HISTORIC AND DESIGN REVIEW COMMISSION

HDRC CASE NO: 2021-324
ADDRESS: 909 N HACKBERRY ST
LEGAL DESCRIPTION: NCB 529 BLK 2 LOT N 92.5 FT OF 13 & 14
ZONING: IDZ-1, H
CITY COUNCIL DIST.: 2
DISTRICT: Dignowity Hill Historic District
APPLICANT: Michael Garansuay/GARANSUAY MICHAEL S & TERESA P
OWNER: Michael Garansuay/GARANSUAY MICHAEL S & TERESA P
TYPE OF WORK: New construction of two, 2-story residential structures and two, 1-story residential structures
APPLICATION RECEIVED: June 30, 2021
60-DAY REVIEW: Not applicable due to City Council Emergency Orders
CASE MANAGER: Edward Hall
REQUEST:

The applicant is requesting a Certificate of Appropriateness for approval to construct two, 2-story residential structures and two, 1-story residential structures on the vacant lot at 909 N Hackberry, located within the Dignowity Hill Historic District.

LANDSCAPE PLANTING PLAN

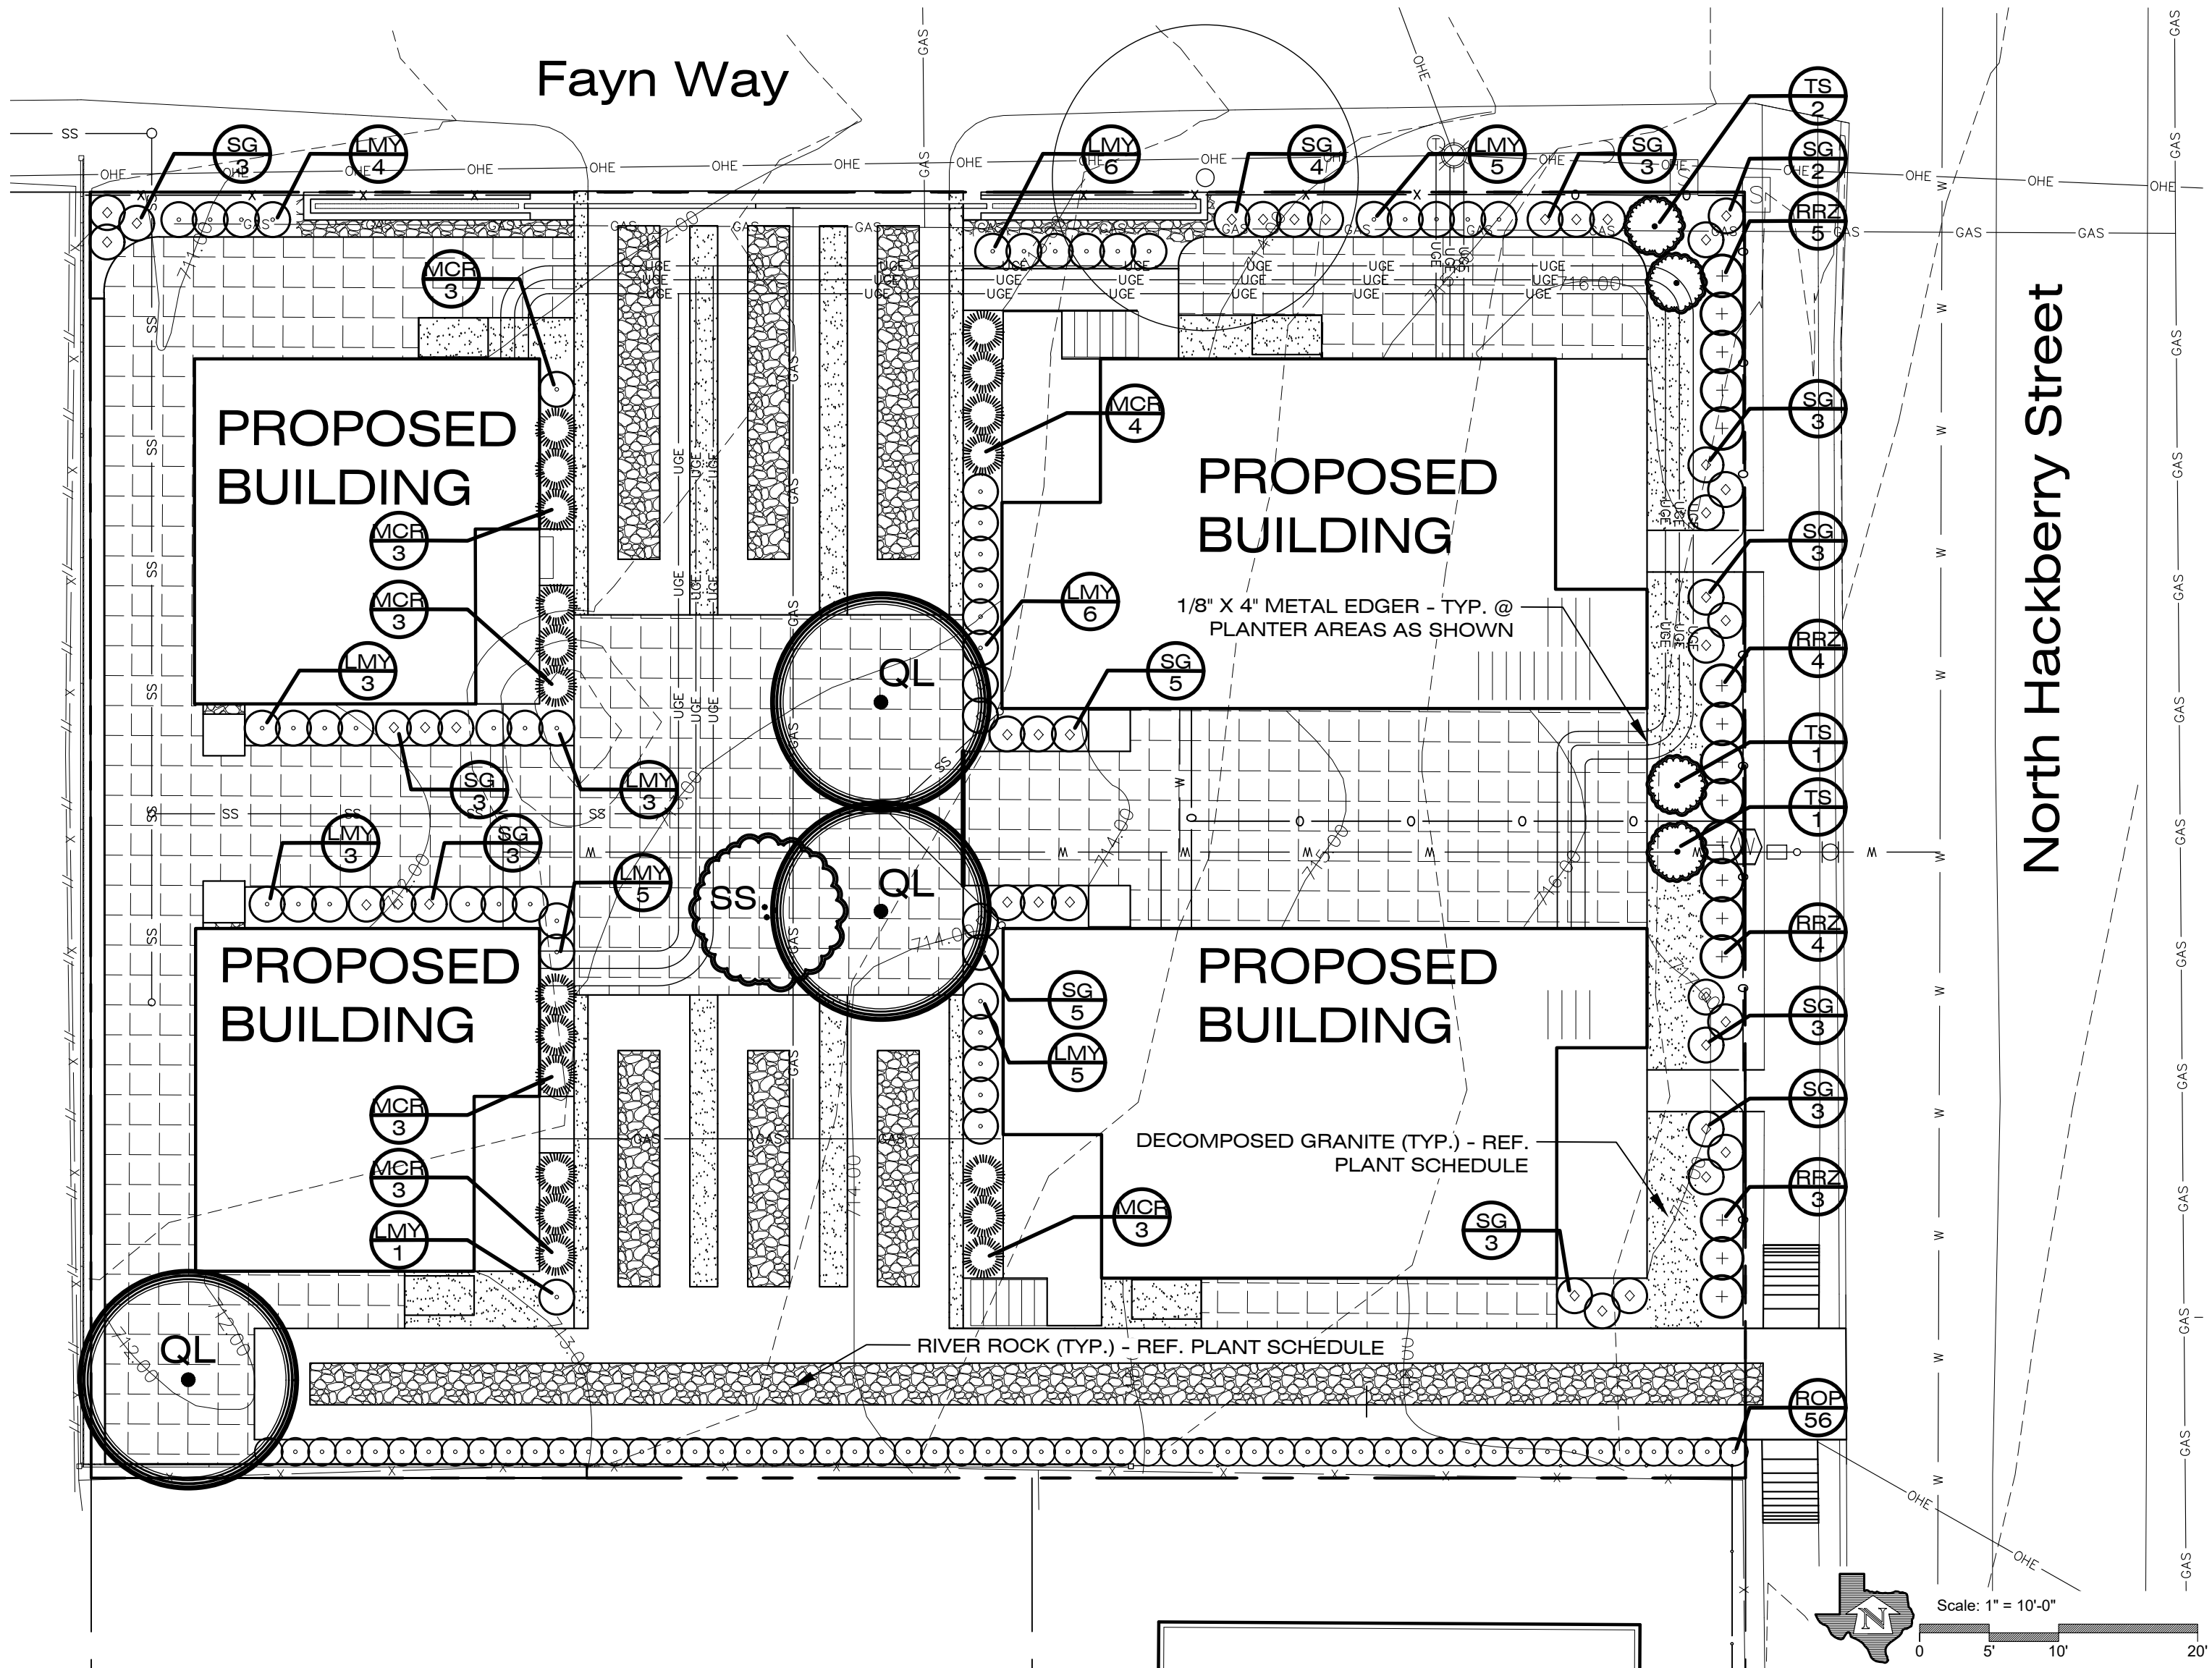
- s. LANDSCAPING – The applicant has submitted a detailed landscaping plan that notes the installation of site pavers and decomposed granite throughout the site. Generally, staff finds the use of decomposed granite and site pavers to be appropriate; however, staff finds that front yards should feature fifty (50) landscaping ground cover.

ARCHITECTURAL SITE PLAN

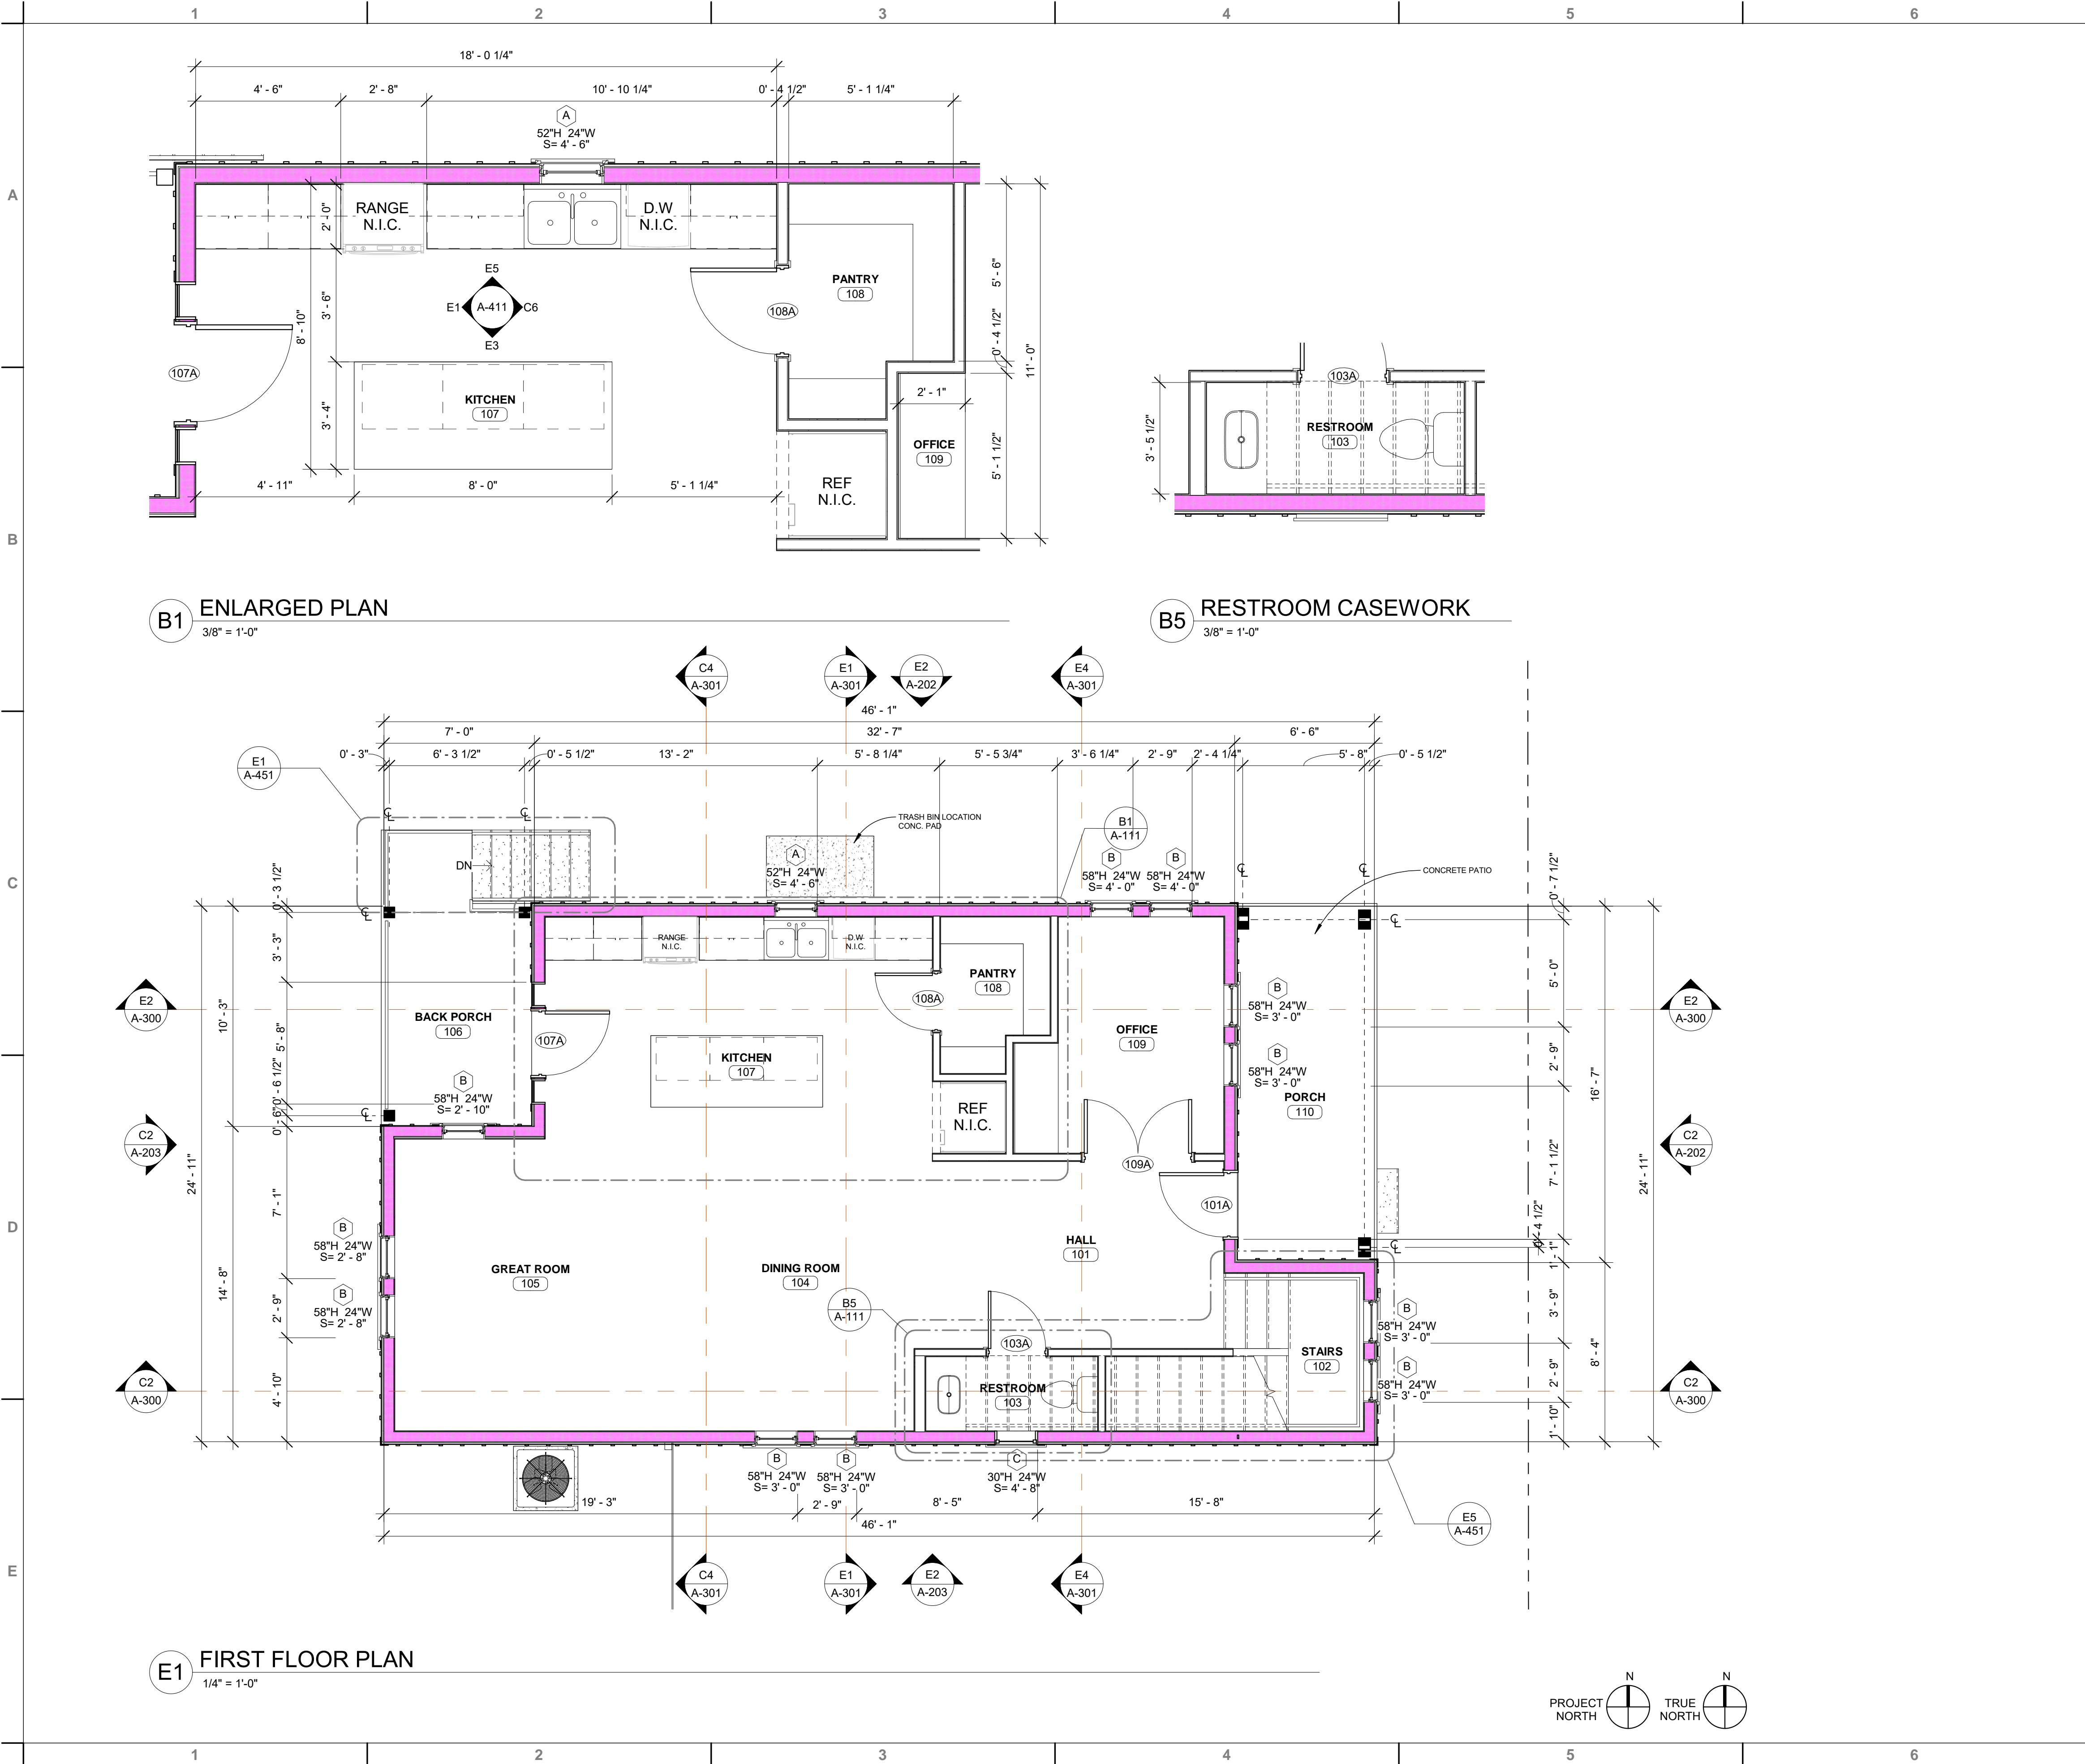
- l. **LOT COVERAGE** – Per the submitted site plan, it appears that lot coverage is less than fifty (50) square feet; however, staff finds that the applicant should confirm consistency with the Guidelines.
